Mark Robertson
Senior Project Manager, Barangaroo
Lend Lease
30 The Bond, 30 Hickson Road, Millers Point

Barangaroo South - Stage 1a Public Domain Works (SSD 6303), Hickson Road, Millers Point

Re: Barangaroo South - Stage 1a Public Domain Works (SSD 6303), Hickson Road, Millers Point

Attachment 1: Stage 1a Public Domain, ORWS RAP and HHR boundaries and Groundwater Retention Wall (D Wall) Alignment
Attachment 2: Stage 1a Public Domain Proposed Development

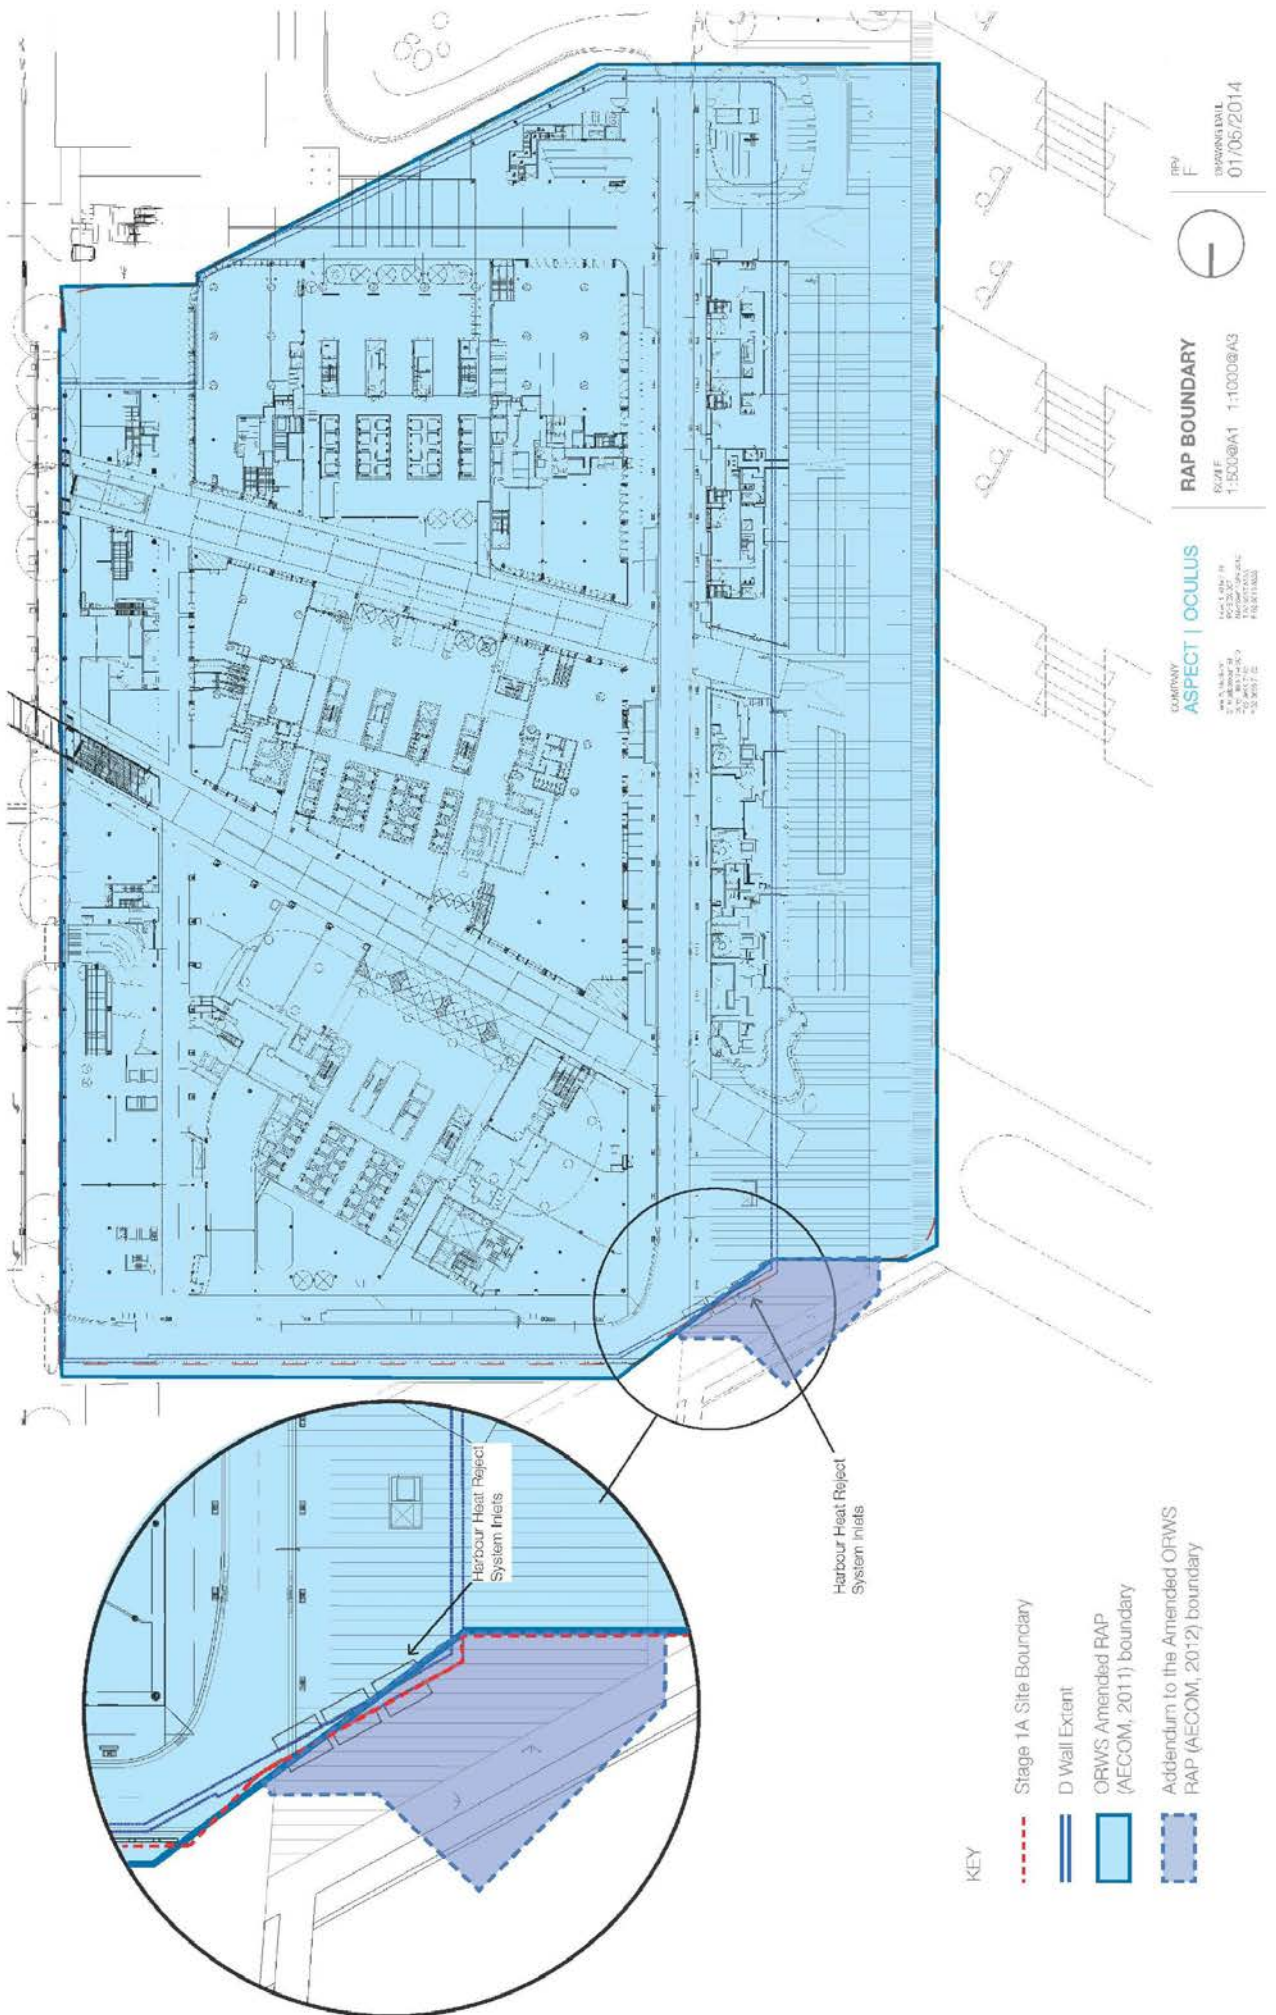
Aspect	Details	Auditor Comments
Northern boundary (west portion/ HHR area)	<p>East: Stage 1a boundary falls outside groundwater retention wall but inside ORWS RAP boundary. Maximum distance of 2.5m beyond the groundwater retention wall. This adjustment has resulted in additional material being retained outside the groundwater retention wall.</p> <p>Quantity of soil to be retained outside the groundwater retention wall considered by AECOM to be small.</p> <p>Surface soil in this area will be excavated for construction of the HHR system and excavation to 0.6m will be performed under the proposed roadway, to be managed as a 'limited excavation' as contemplated in the ORWS RAP.</p> <p>No data available from this specific area. AECOM presented previous data from nearby locations and compared to Area A criteria from ORWS RAP (criteria relevant to retained fill).</p>	<p>Considered acceptable based on analytical results and quantity of material involved, noting that Auditor sign-off will relate to Stage 1a boundary which is not consistent with the groundwater retention wall boundary at this location.</p> <p>HHR and ORWS RAPs to apply to works.</p>

<p>West: Stage 1a boundary aligns with groundwater retention wall and falls outside ORWS RAP boundary but inside HHR area. This adjustment has resulted in less material being retained outside the groundwater retention wall.</p>	<p>Considered acceptable noting that retention of less material outside the groundwater retention wall is more conservative.</p>
Northwest corner	Stage 1 boundary is curved and falls inside the angular ORWS RAP boundary.	Considered acceptable.
Southeast corner	Stage 1 boundary cuts the corner and falls inside the ORWS RAP boundary.	Considered acceptable.
Southern boundary (east portion)	<p>Stage 1a boundary coincides with the ORWS RAP boundary but falls outside the groundwater retention wall which was constructed in a different position to proposed. This adjustment has resulted in additional material being retained outside the groundwater retention wall. Quantity of soil to be retained outside the groundwater retention wall reported by AECOM as small.</p> <p>No data available from this specific area. AECOM referenced previous data from nearby locations and compared to Area A criteria from ORWS RAP (criteria relevant to retained fill).</p>	<p>Quantity of material retained outside the groundwater retention wall not considered by the Auditor to be 'small', noting a maximum distance of 2.5m from the groundwater retention wall over a distance of nearly 100m and fill depth of over 15m. ORWS RAP aspects for Area A should apply to the area outside the groundwater retention wall. Auditor sign-off will relate to Stage 1a boundary which is not consistent with the groundwater retention wall boundary at this location.</p>
